Errata Sheet

Rel. 1.3, 2014-02-21

Device	**TC1762**
Marking/Step	**EES-AC, ES-AC, AC**
Package	**PG-LQFP-176-2**

Figure 2 Timing concerning equidistant multiple timers

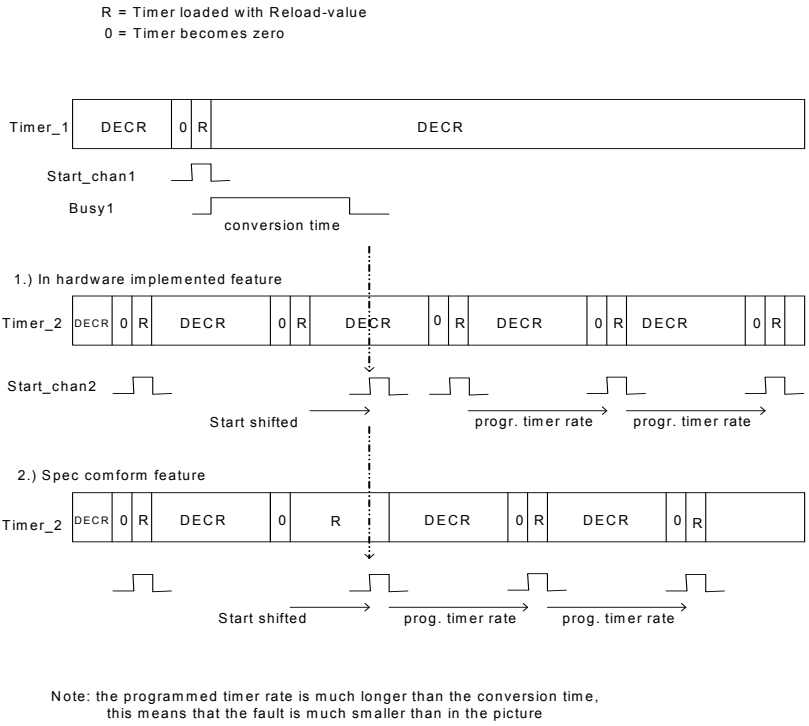
The correct behavior would be a reload when the requested conversion (of channel_2) is started.

Therefore the start of conversion for channel_2 is delayed by maximum one conversion-time. After this delay it will be continued with equidistant conversion-starts. Please refer to the following figure.

Figure 3 Uncritical transmission

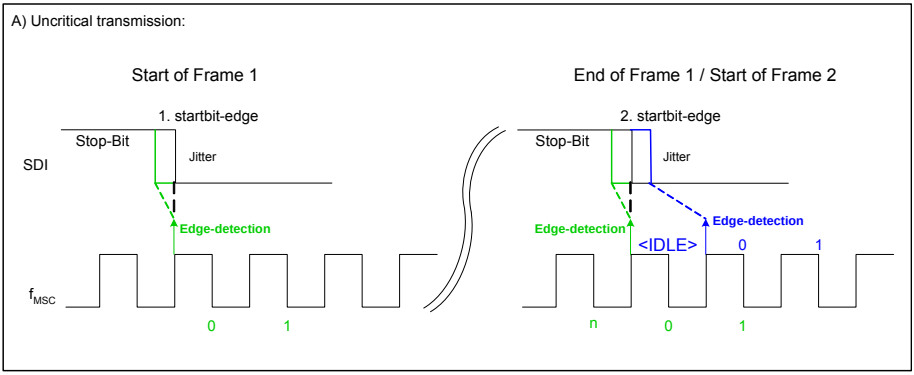
As the falling startbit edge is shifted to the left of the rising clock edge (**Figure 3** left), there occurs a secure detection of the next start-bit edge in the last cycle of the previous frame (here cycle n, **Figure 3** right) independant from the applied jitter to this edge.

Figure 4 Critical transmission

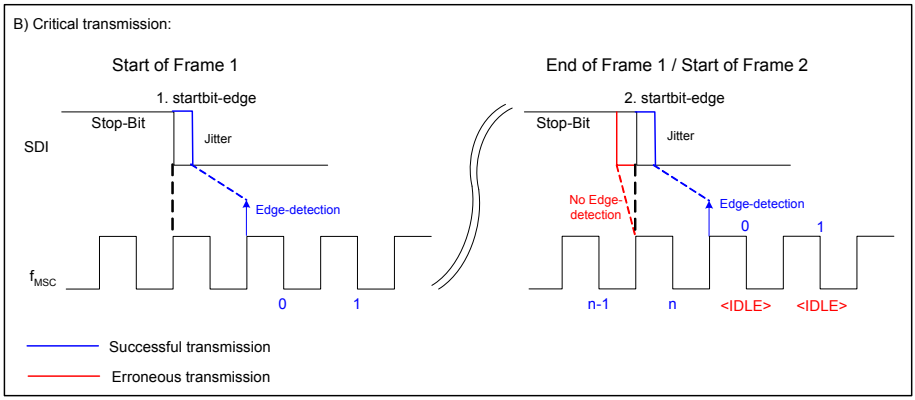
If the high-low edge of the start-bit in the first frame is just not detected by the near clock-edge (**Figure 4** - left) and the start-bit edge of the second frame is jittering to cycle n-1 (**Figure 4** - right, red coloured), then an erroneous transmission will take place. In this case the state-machine switches to IDLE after the last state n and wakes up on the next falling edge that may be a data-bit recognized as a start-bit. If the start-bit of the second frame is jittering to cycle n (**Figure 4** - right, blue colored), then the state-machine will not switch to IDLE but will start receiving the next frame correctly.

Figure 5 Delay adjustment relative to the module clock

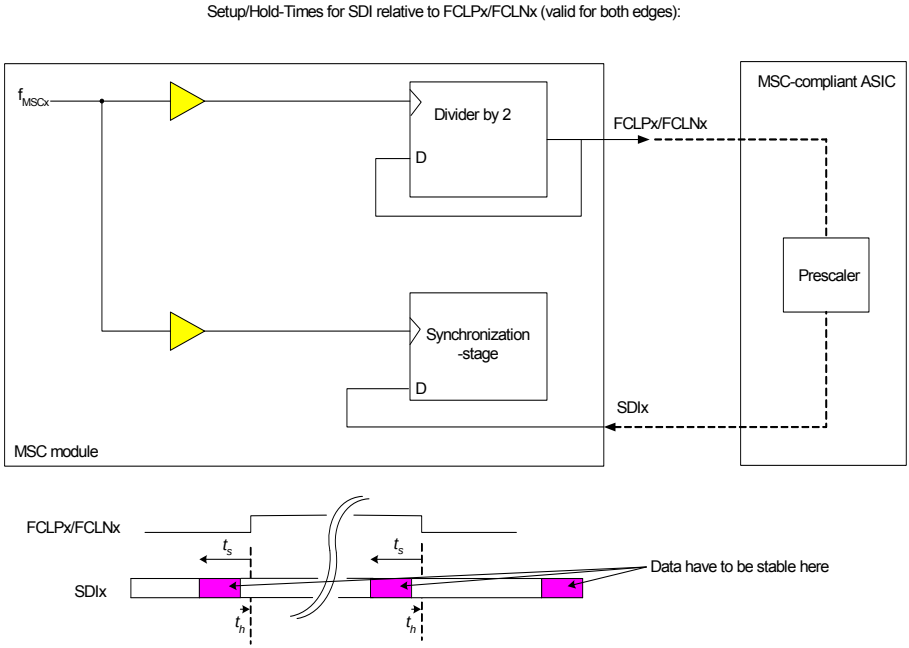
The delay depends on the maximal skew in the data-stream. For this workaround the downstream clock FCLPx/FCLNx can be measured as reference and the data stream at the input of the upstream channel SDIx has to be adjusted according to the setup- and hold-times of the input-pins SDIx.

Figure 5 shows the principle blockdiagram of the input synchronization stage of the MSC module.

Figure 9 Current accuracy range

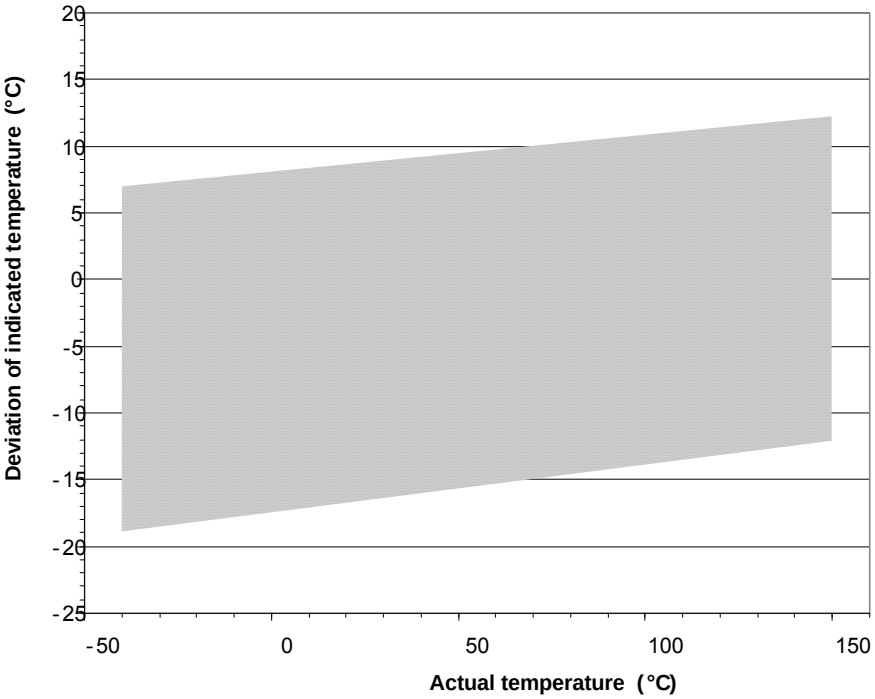
The accuracy of the DTS deviates from the values specified in the Data Sheet. The formulas available on the specification are as follows:

The deviation using these formulas is:

- +/-12°C at T_J = 150°C
- +9/-17°C at T_J = 25°C
- +7/-19°C at T_J = -40°C

Figure 10 Exemplary power-up/down sequence

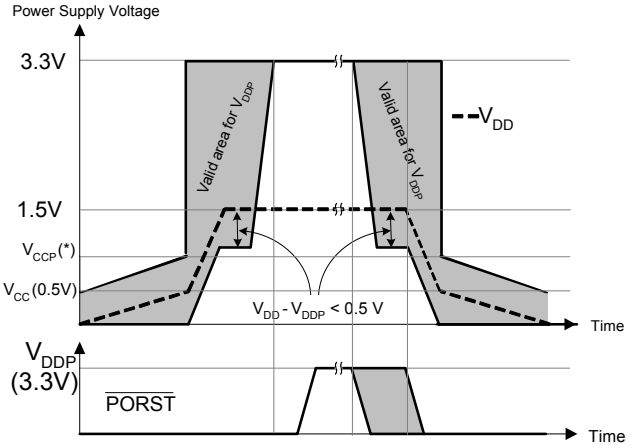
As per Data Sheet, V_{DD} - V_{DDP} < 0.5 V has to be valid at any time in order to avoid increased latch-up risk. The figure below shows the possible V_{DDP} values as shaded region for an exemplary V_{DD} ramp. Moreover, the following rules apply:

- All analog voltages (V_{DDOSC3}, V_{DDM}, V_{DDMF}, V_{DDFL3}) must also follow V_{DDP} power-up/down sequence.
- V_{DDAF}, V_{DDOSC} must follow V_{DD} power-up/down sequence.
- The absolute value of the maximum allowed deviation between any two supplies is 0.5 V while the 1.5V supplies are below their specified operating conditions.

*Note: V_{CC} and V_{CCP} in **Figure 10** refer to devices with PWR_TC.P009 erratum.*
